MEMPHIS AND SHELBY COUNTY OFFICE OF PLANNING AND DEVELOPMENT
STAFF REPORT **11**

CASE NUMBER: P.D. 08-315 **L.U.C.B. MEETING:** November 13, 2008
Held from June 12, 2008

DEVELOPMENT NAME: Gameday Sportsplex Planned Development

REQUEST: A Mixed Use Sports Complex to include indoor courts, retail, restaurant, and hotels

Revised Plan

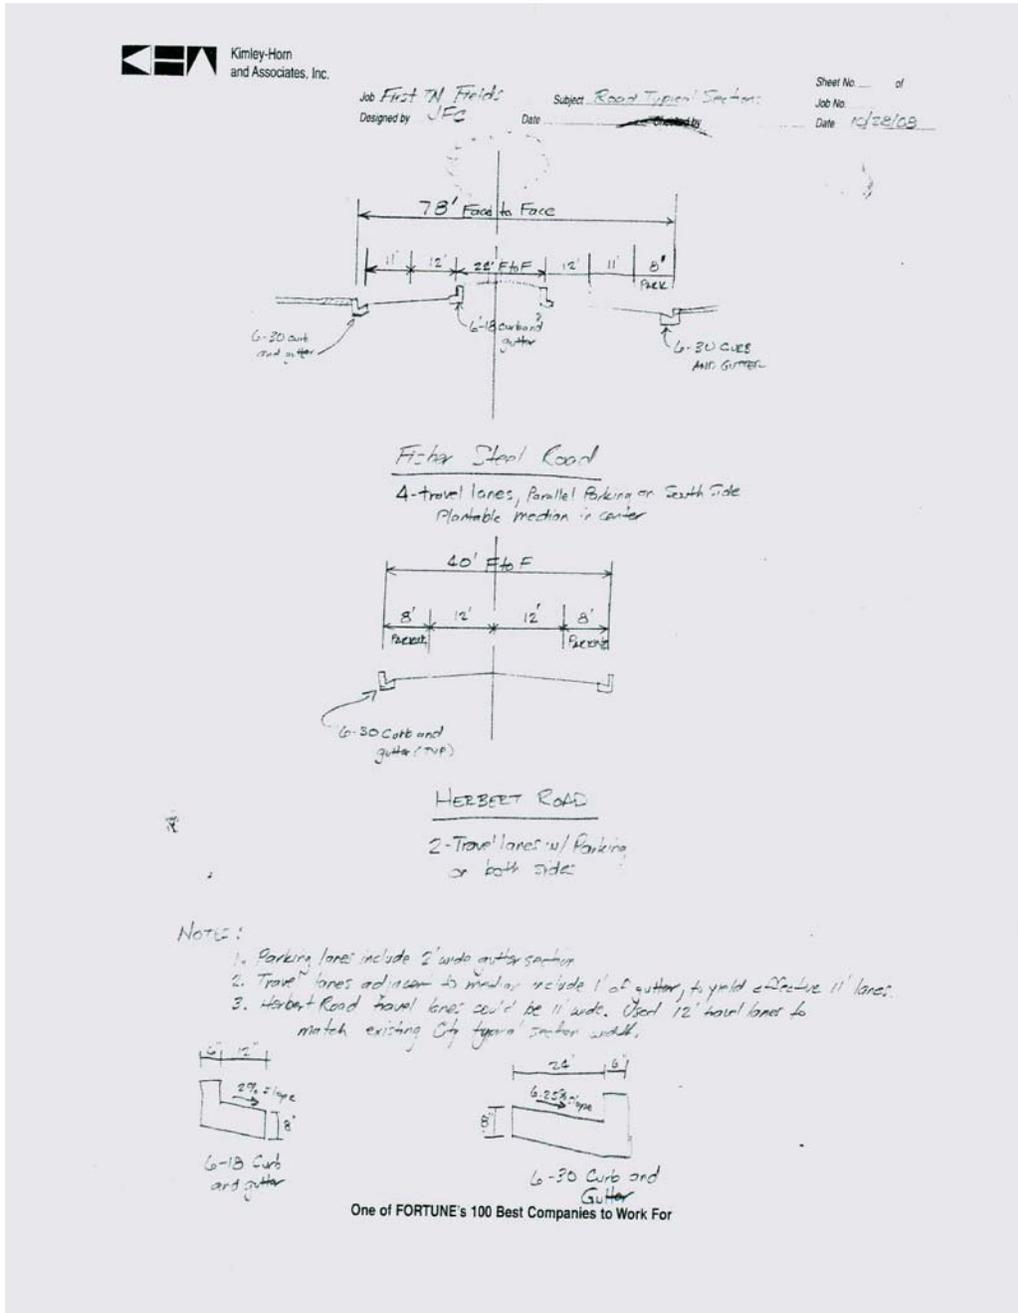
3. The revised site plan is a direct result of the Charrette process which demonstrated that the primary retail elements of the applicant's program can be met by moving the buildings closer to the street and encouraging a pedestrian environment. This pedestrian environment is continued with respect to the development of the street cross sections which include a median, pedestrian cross walks, and traffic calming devices.

4. The recommended revised site plan deviates from the plan that was produced through the Charrette process. We are in agreement that shifting the proposed east-west street to the south will still allow for future connectivity.

The revised site plan is a direct result of the Charrette process which demonstrated that the primary retail elements of the applicant’s program can be met by moving the buildings closer to the street and encouraging an pedestrian environment. This pedestrian environment is continued with respect to the development of the street cross sections which include a median, pedestrian cross walks, and traffic calming devices.

There are some deviations from the Charrette Plan that require some discussion and there are some instances where the recommended conditions are not in keeping with the applicant’s desires. These are discussed below.

Building Placement – The Arenas - The draft Charrette Plan places all but one of the proposed buildings at the Fischer Steel sidewalk. The applicant makes the case that the arenas are a

different type of facility than the other buildings in this project. They are more pure destination buildings and far less retail oriented. Their operational requirements for drop off and pick up are quite different and they require a different treatment.

CSX Rail Spurs and Multi-family Buildings – The Charrette Plan calls for lining parts of the east west and south sections with a row of townhouse or apartment buildings to be served by the future acquisition of the rail spur lines and the developing them into an east-west and north-south road.

The applicant makes the point that not only would this use need parking space, but it would also require the applicant to either become a residential developer or sell part of his property to a residential developer. The applicant also points out that the east-west section of the spur line cuts through on an angle which complicates the development on the north side of that rail line. They offer that moving the future road further south would provide for a better development pattern with one developer controlling the land on both side of the road.

There does appear to be sufficient land to accommodate this shift and provide some necessary connectivity.

Proposed Road Cross Sections

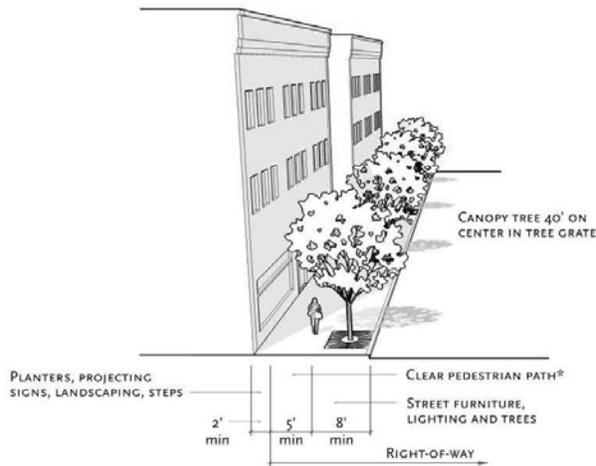
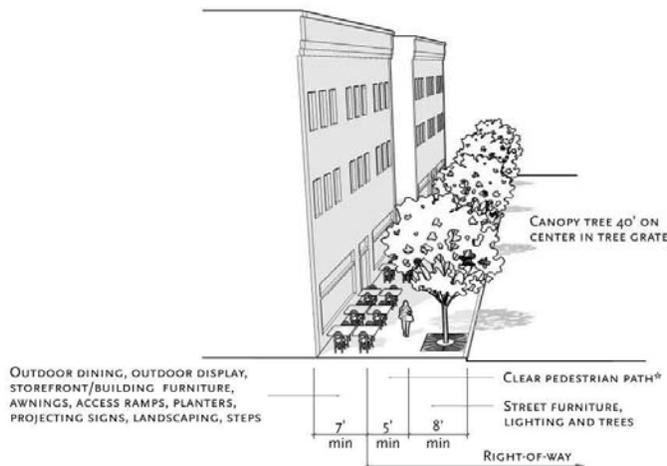
Timing of Streetscape Improvements – The staff sees the streetscape improvements (sidewalks, street trees) as a defining ingredient in establishing the character of this area for future development. As such, the recommendation is to put the streetscape in with the first phase to set the tone for other developments to follow. Delaying its implementation to a later time is presents a piece meal approach which will not produce the desired consistent appearance. Pedestrians in the early phases of this project's development will be just as dependent on sidewalks as pedestrians who visit the project in its final stages.

- B. Streetscape: The required streetscape for both the south side of Fischer Steel Road and Herbert Road shall be as follows:
1. A 13 foot side walk -the 8 feet closest the curb is reserved for street trees in grates and street furniture such as Light Poles, Fire Hydrants), the remaining five feet is for a clear pedestrian path. A building setback ranging from 2 feet to 7 feet..

2. A 10 foot wide sidewalk with street trees shall be required along the north side of Fischer Steel Road.
- C. Pedestrian Cross Walks and Traffic Calming:
